Subject: AP1000 COL Responses to Requests for Additional Information (TR 85)

In support of Combined License application pre-application activities, Westinghouse is submitting responses to the NRC requests for additional information (RAIs) on AP1000 Standard Combined License Technical Report 85, APP-GW-GLR-044, Nuclear Island Basemat and Foundation. These RAI responses are submitted as part of the NuStart Bellefonte COL Project (NRC Project Number 740). The information included in the responses is generic and is expected to apply to all COL applications referencing the AP1000 Design Certification.

Responses to Requests for Additional Information on Technical Report No. 85

AP1000 TECHNICAL REPORT REVIEW

Figure RAI-TR85-SEB1-14-1- SSE Comparison of Linear Springs to Non-Linear (liftoff)

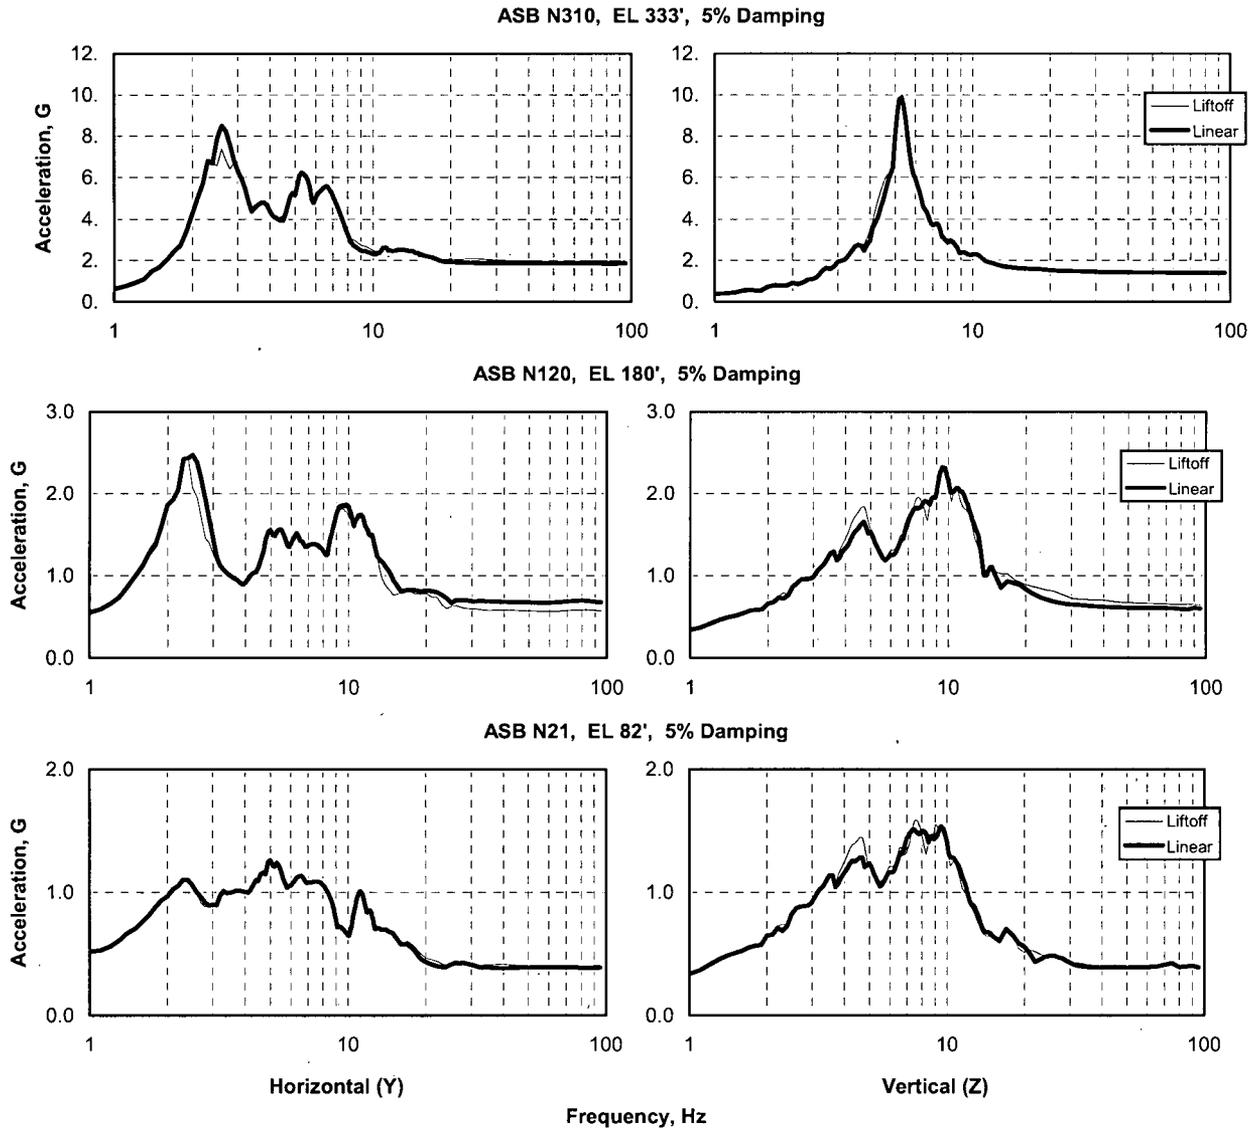
In Section 2.4.2, the last paragraph (Page 11 of 83) states that comparison of floor response spectra and the maximum member forces and moments for the two cases (the case of linear soil springs able to take both tension and compression, and the case of nonlinear soil springs where the vertical springs act in compression only and the horizontal springs are active when the vertical springs are closed and inactive when the vertical springs lift off) show that the lift-off has insignificant effect on the SSE response. Provide these comparisons (figures and/or tables) in the technical report.

The floor response spectra comparisons were provided in Figure 7.2-1 of Reference 1 (TR03) for soft to medium soil. They are shown in Figure RAI-TR85-SEB1-14-1. The lift-off has insignificant effect on the SSE response.

Figure RAI-TR85-SEB1-1 Soil Bearing Pressure in Load Case 3-9 (+0.4xSns+1.0xSew+0.4xSvt)

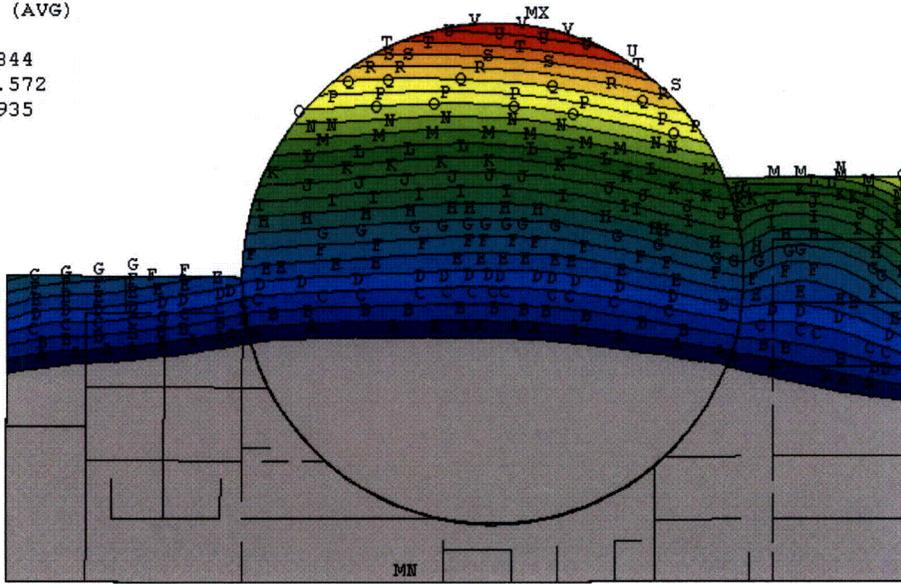
- c. Provide the contour plot for the case of +0.4 NS +1.0 EW +0.4 Vertical, which may be a worst case since the dimension of the auxiliary building in the North direction from the centerline of the NI is smaller than the dimension in the South direction. Was a review done to ensure that the figures in Section 2.6 represent the bounding maximum and minimum cases?

- b. See response to part (b) of RAI-TR85-012.
- c. The contour plot for the case of +0.4 NS +1.0 EW +0.4 Vertical is shown in Figure RAI-TR85-SEB1-1. The figures in Section 2.6 represent the bounding maximum and minimum cases at the corners and west edge of the shield building as summarized in Table 2.6-3. Results for 16 cases were considered in the basemat design as identified in the response to RAI-TR850SEB1-27.

Figure RAI-TR85-SEB1-1 Enlarged View of East End of Vector2 Model on Soil Springs

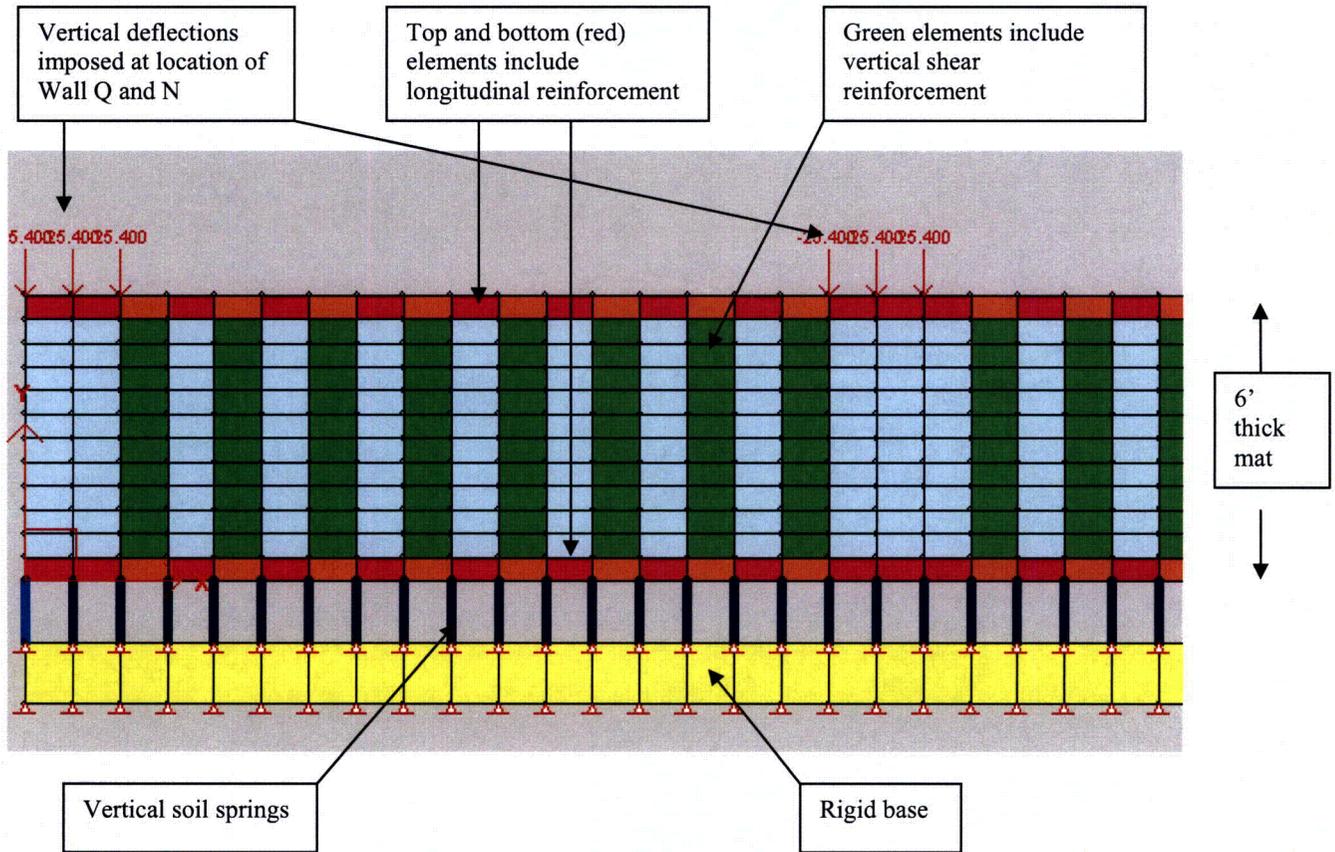
Section 2.7.2 describes the study of the two critical bays of the basemat using the VECTOR computer code. From the very short description of the three analytical models (a, b, and c), which are also shown on Figures 2.7-5, 2.7-6, and 2.7-7, it is not evident what the models consists of and the associated loading. Provide further information to describe the model and loading, including labeling of the models to explain each feature shown in the figures. Also, describe how the horizontal restraint from the soil (referred to in Section 2.7.2, fifth paragraph) was modeled since it appears to have a very significant impact on the half-space model.

Figure RAI-TR85-SEB1-1 provides an enlarged view of the west end (bay Q to P) of the model of the basemat (Figure 2.7-6). The concrete and reinforcement is represented in the model as described in the annotations to the figure. Vertical displacements are imposed at the location of the auxiliary building walls Q, P, N, and L, thereby pushing the model down onto the soil springs.
